HPK/2026/0228 - Full Planning Permission for the repurposing of part of the existing Spring Gardens Shopping Centre, including partial demolition, and new development to create a series of development blocks to deliver residential units (Use Class C3) and commercial floorspace (to include flexibility for Use Classes E -commercial, F1 - learning and non-residential institutions, and Sui Generis - drinking establishments, cinema), new public realm and landscaping to include public squares and residential courtyards, new car parking and associated works – The Springs Shopping Centre, Buxton

OBJECTION — Firstplan on behalf of Waitrose & Partners

TRANSPORT TECHNICAL NOTE

The Springs Shopping Centre and Spring Gardens

Drawing 8260548/3101 — Proposed Walking Routes (based on al(04)0100 Rev P08)

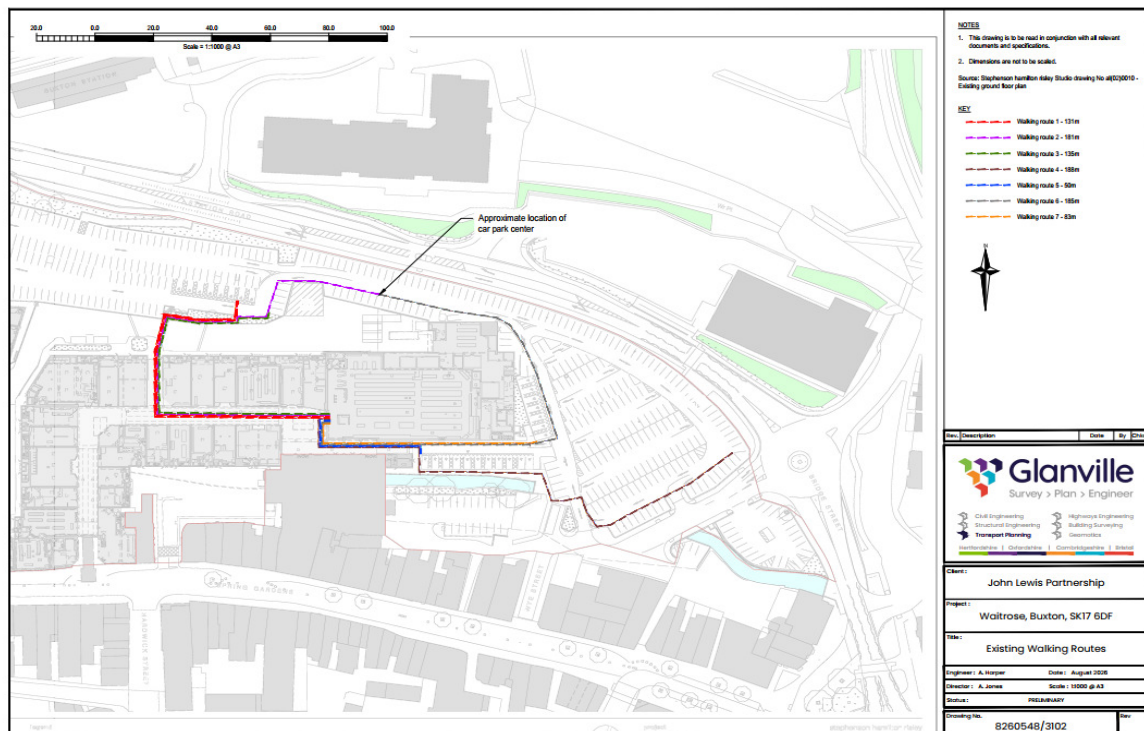
- 4.8 We have accordingly measured the routes ourselves, from the submitted general arrangement drawings at their stated scales; the measurements are presented on drawings 8260548/3101 and 8260548/3102 at Appendix A. Measured to the main Waitrose store entrance in each case, the designed pedestrian route from the car park's southern stair-and-lift core, via a crossing of the internal vehicular route, the entrance lobby within Block 10 and the length of the internal mall, measures 95 metres; from the nearest accessible bay 109 metres; and from the furthest ground-level space 146 metres. Spaces on the upper level depend in addition on the single stair-and-lift core. The corresponding existing routes measure 135 metres from the nearest ordinary public space, 181 metres from the approximate centre of the car park and 188 metres from the furthest public space. It should be recorded plainly that, for ordinary public parking, the proposed arrangement is therefore not more distant than the existing one and in those respects is shorter; the applicant's own demolition plan (Design and Access Statement, page 38) also identifies several existing points of access into the shopping centre directly from the car park frontage, in place of the single stair-and-lift core proposed. The material changes lie elsewhere, in accessible provision (Section 5) and in the character of the route. Whether any of the upper-level spaces would be available to customers of the store is unclear: allocation is stated by deck level, which the drawn level counts cannot deliver. If the upper level is in practice residential, all parking for customers of the Waitrose store would sit on the ground level, which is also the level the Flood Risk Assessment designs as a route for flood water and on which all of the accessible bays are placed. At the Transport Assessment's own 80 metres-per-minute convention these are straightforward calculations; the Transport Assessment performs none of them.

- 4.9 The measurements also disclose a change in the character of the route which distance alone does not capture. Under the existing arrangement a customer parking in the eastern car park reaches the store without passing through the internal mall; routes 4, 6 and 7 on drawing 8260548/3102 are of that character, whereas routes 1, 2 and 3 pass internally. The proposals remove the eastern car park, which contains, in the section to the south of the store, the nearest accessible parking to the store entrance, and every route from the replacement decks measured on drawing 8260548/3101 crosses the internal vehicular route, passes through the Block 10 lobby and then runs the length of the internal mall. That vehicular route, on the applicant's own drawing al(04)0100, continues eastwards to serve the Waitrose service yard. Under the existing arrangement no such conflict arises: the topographical survey al(02)0002 shows servicing segregated from customer movement, via Pontefract Way to the rear of the store, marked one-way, "keep clear" and "strictly no parking". The proposals therefore introduce a crossing of a service vehicle route into the only pedestrian route between the car park and the Waitrose store, on which the return leg is made with a loaded trolley; neither the frequency nor the types of vehicle using that route, nor the interaction between them and pedestrians, is assessed anywhere in the submission. For a main food shopping trip the distinction is material: the return leg is made with a loaded trolley, and the trolley route, its containment and the suitability of the internal mall for that purpose are matters the submission does not address, the word "trolley" appearing nowhere in the Transport Assessment or its appendices. The Design and Access Statement's own convenience claim is instructive in this respect: it states that the lowest car park level aligns with the entrance to The Springs Shopping Centre (page 78), which is the entrance to the centre and not to the store, the latter lying beyond it along the mall. Because no beneficiary or trip purpose survey was undertaken, the submission cannot say how many customers presently use the eastern car park for that reason, and the Transport Assessment does not address the point at all.

- 5.2 The existing car park provides 24 disabled spaces equating to 38% of the Council's accessible parking stock of 64 spaces. The proposed car park provides accessible spaces at 5% of 260, approximately 13. The general arrangement drawings identify approximately twelve accessible bays, all at ground level and clustered at the southern stair-and-lift core, an appropriate location, and one the transport evidence nowhere describes or secures. The proposals remove roughly 17% of the town centre's entire accessible parking stock, and place the whole of the replacement accessible provision on the lowest level of the car park. This is the level the Flood Risk Assessment classifies as "allowed to flood" and designs as an "open route for flood water" (Table 3.4).

- 5.3 Customers with impaired mobility are precisely those for whom walking distance, gradient and dependence on lifts bind hardest, and for whom reassignment to a more distant car park is least available as an answer. On the measured routes at Appendix A, the walk from the nearest accessible bay to the main store entrance lengthens from 50 metres today to 109 metres, more than double, and includes a crossing of the internal vehicular route which serves the Waitrose service yard, and the length of the internal mall. The existing arrangement further offers accessible parking in three separate locations, at 50, 83 and 131 metres from the entrance, so that a customer unable to find a space in one may use another; the proposals replace that choice with a single cluster at 109 metres. The two nearest of those locations, at 50 and 83 metres, both lie within the eastern car park, which the proposals remove; the accessible parking closest to the Waitrose store today is therefore the provision most directly displaced. The local planning authority is subject to the public sector equality duty under the Equality Act 2010 in determining the application; the submitted evidence contains no assessment of the effect of the reduction in accessible provision, its location within the new car park, or the step-free route to the Waitrose store, on which that duty could be discharged.

- A.1 Source and scale. Walking distances have been measured by Glanville Consultants and are presented on drawings 8260548/3101 (Proposed Walking Routes, 1:250 at A3) and 8260548/3102 (Existing Walking Routes, 1:1000 at A3), appended. The proposed routes are measured from the applicant's drawing al(04)0100 "Proposed Level 00", Revision P08 dated 4 June 2026, and the existing routes from al(02)0010 "Existing Ground Floor Plan", both by stephenson hamilton risley STUDIO and obtained from the Council's public planning register.

- A.2 Method. Each route has been measured as a walked polyline following the aisles, footways, crossings and internal circulation available, without straight-line shortcuts through parked rows or building fabric. All routes, existing and proposed, are measured to the main Waitrose store entrance.

- A.3 Results. Proposed (drawing 8260548/3101): from the stair-and-lift core, 95 metres; from the nearest accessible bay, 109 metres; from the furthest ground-level space, 146 metres. Spaces on the upper level depend in addition on the stair-and-lift core. Existing (drawing 8260548/3102): from the nearest accessible bays, located within the eastern car park in the section to the south of the store, 50 metres; from the accessible bays adjacent to the eastern building edge within the same car park, 83 metres; from the accessible bays to the north-west of the store, 131 metres; from the nearest ordinary public space, 135 metres; from the approximate centre of the car park, 181 metres via the internal mall and 195 metres via the eastern car park; and from the furthest public space, 188 metres.

Amendment / requirement	Basis	Securing mechanism
Allocated short-stay parking for customers of the Waitrose store within the commercial deck, subject to a maximum stay and enforcement, sited adjacent to the vertical circulation serving the Waitrose store	No parking management strategy of any kind is proposed; the Planning Statement's draft Section 106 heads contain no parking head; the Flood Risk Assessment itself requires a long-term management and maintenance plan for the undercroft's floodwater-conveyance function (paragraph 4.3) and a Flood Emergency Plan for any part of the development below flood level (paragraph 4.4), neither of which appears in the submission	Car Parking Management Plan secured by condition, to include flood-event closure, evacuation and reinstatement procedures
Dedicated trolley bays at commercial deck level and at surface level, and a step-free, trolley-capable route between the parking decks and the Waitrose store, with lifts sized accordingly and a defined trolley containment perimeter	The Transport Assessment is silent on trolleys; the Design and Access Statement refers to "dedicated trolley bays" (page 78) and the drawings show trolley stores, without number, capacity or an assessed route; the Stage 1 Road Safety Audit records a significant level change at the site access; and the proposals introduce a crossing of the service access to the Waitrose service yard into the pedestrian route between the car park and the store	Condition and amended general arrangement drawings

Accessible (Blue Badge) parking at a level no lower than the existing 24 spaces, located nearest the vertical circulation, with provision above the design flood level or protected by the management plan	Provision otherwise falls to approximately 13 spaces; the drawings place all accessible bays on the lowest, flood-affected level	Condition and amended drawings
